ADDENDUM TO THE CONTRACT

JNU FIRE ALARM UPGRADE Contract No. BE21-159

ADDENDUM NO.: TWO

DATE ADDENDUM ISSUED: March 3, 2021

SHEET NO.
E-1B422

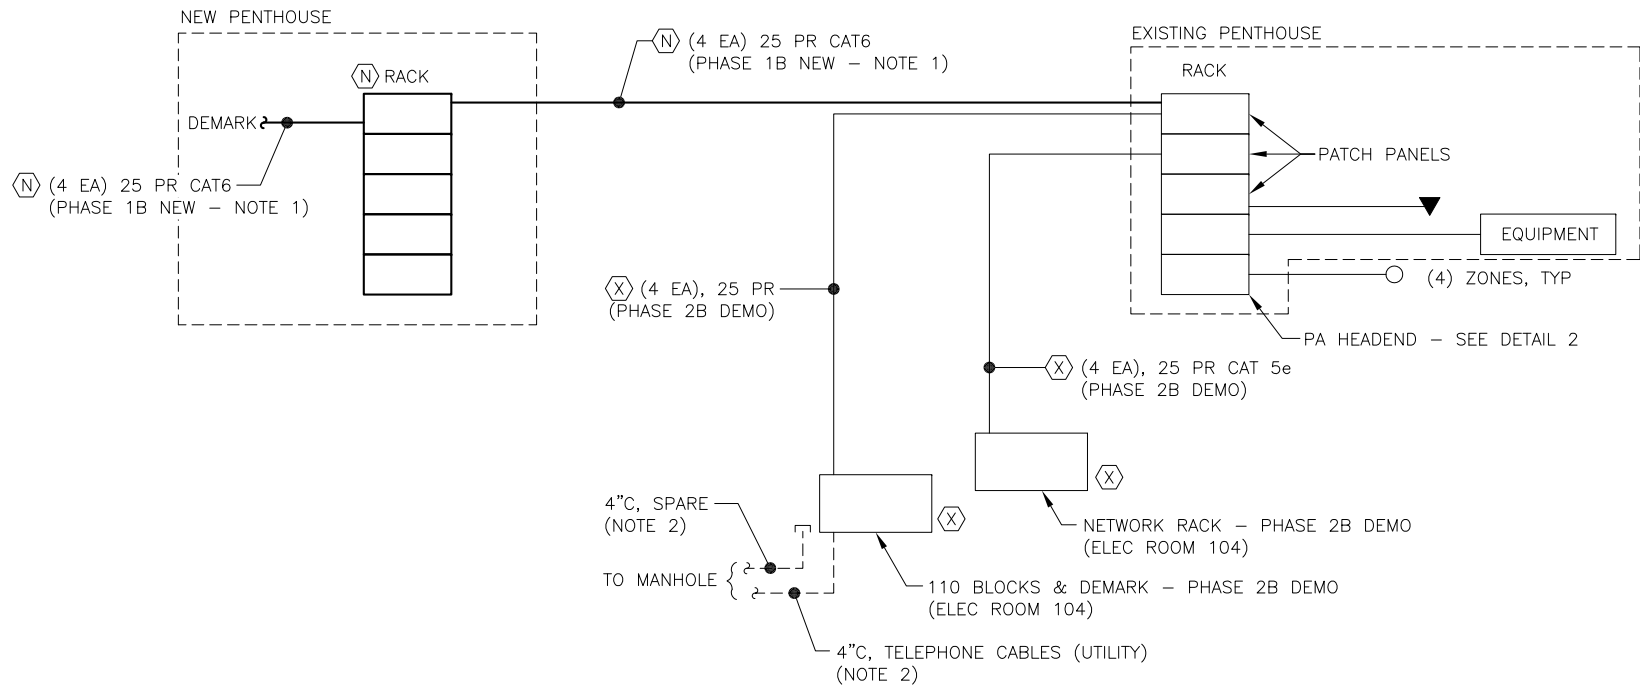
3. Delete PA speaker from the project scope. In its place, furnish and install a ceiling mounted four square electrical box in it's place flush to the sheet-rock with a 3/4\" conduit that terminates horizontally in an accessible ceiling oriented towards the nearest cable tray.

5. Delete PA speaker, wiring and electrical box from project scope.

SHEET NO.
E-902

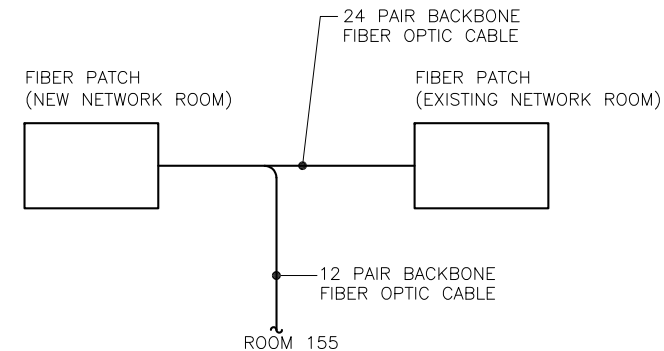
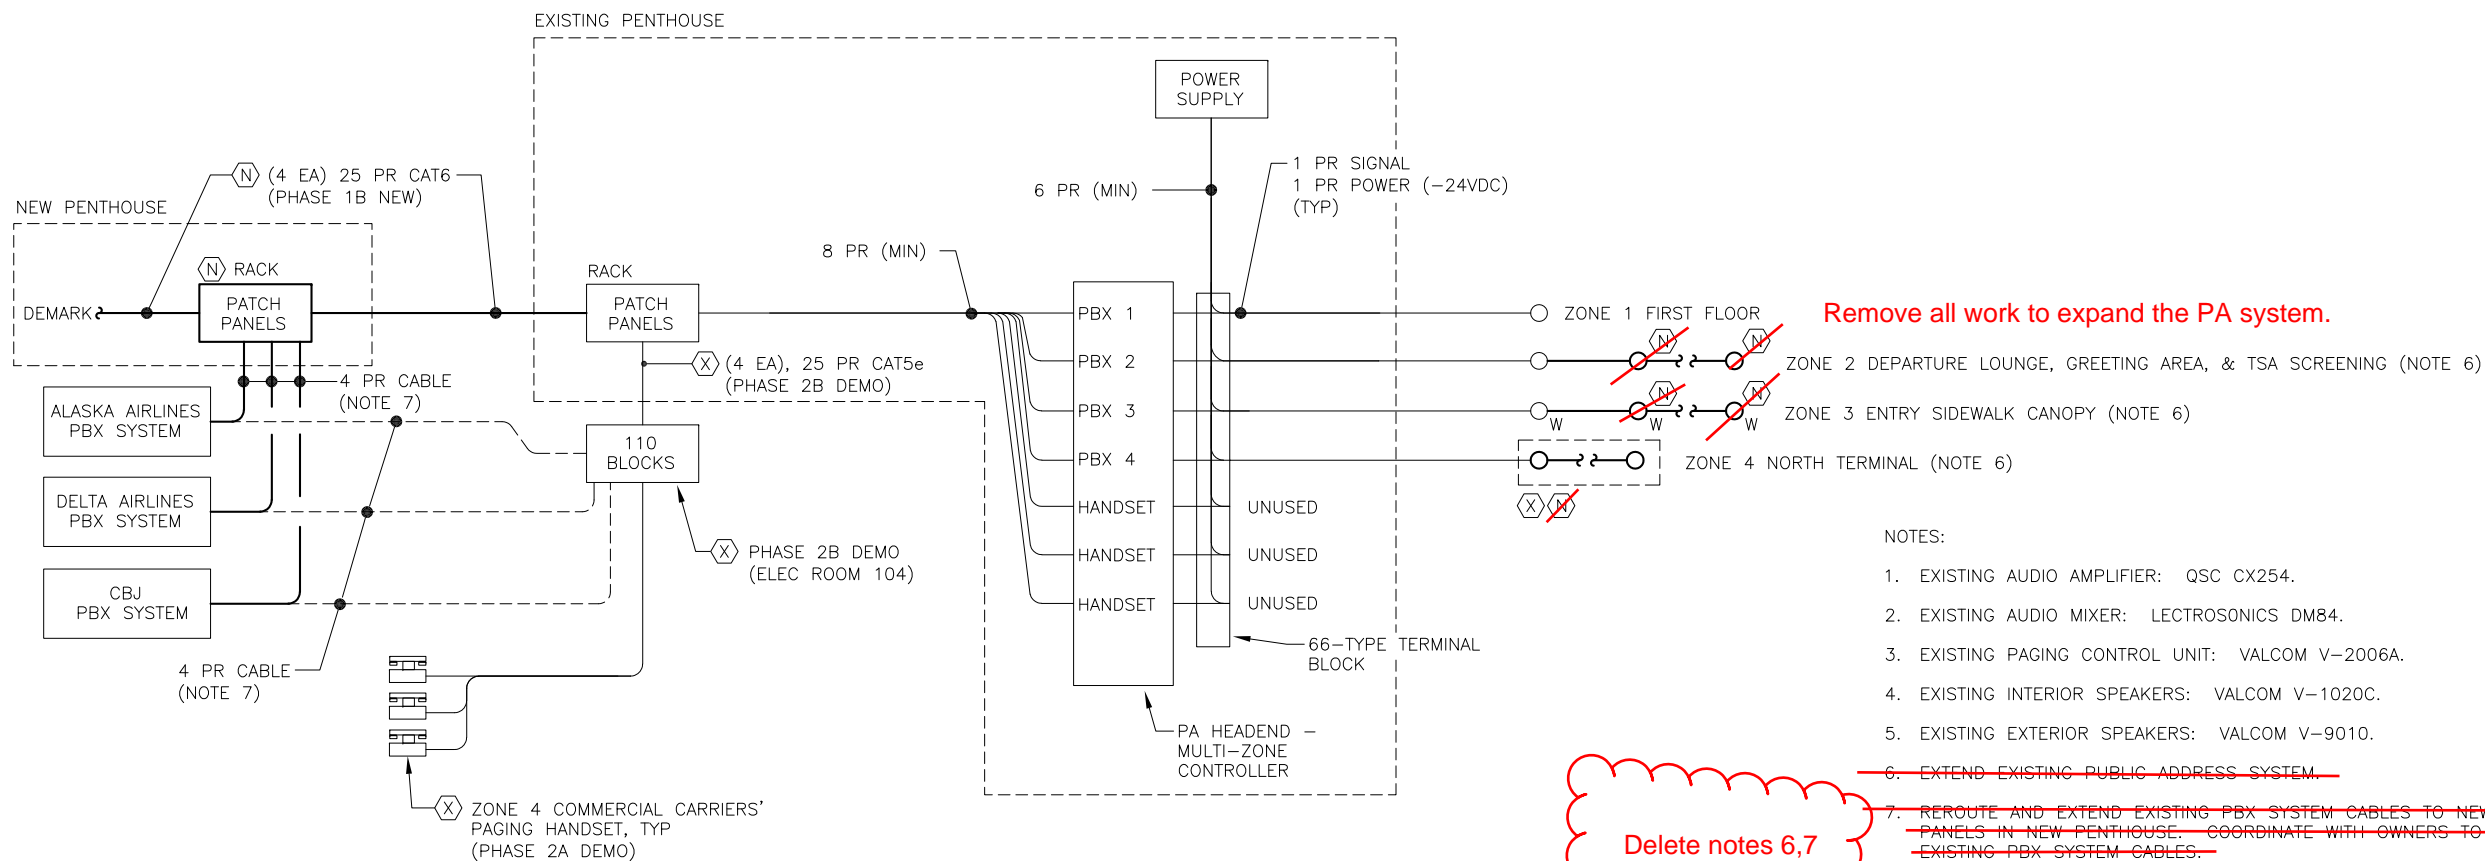
Remove all work to expand the PA system.

~~8. PROVIDE (1 EA) NEW AUDIO AMPLIFIER FOR NEW NORTH TERMINAL SPEAKERS. THE NEW AMPLIFIER SHALL BE COMPATIBLE WITH THE EXISTING AMPLIFIER AND SHALL HAVE A MINIMUM LOAD RATING OF 200W. INTEGRATE NEW AUDIO AMPLIFIER AND SPEAKERS WITH EXISTING PUBLIC ADDRESS SYSTEM.~~

Delete notes 6,7 and 8
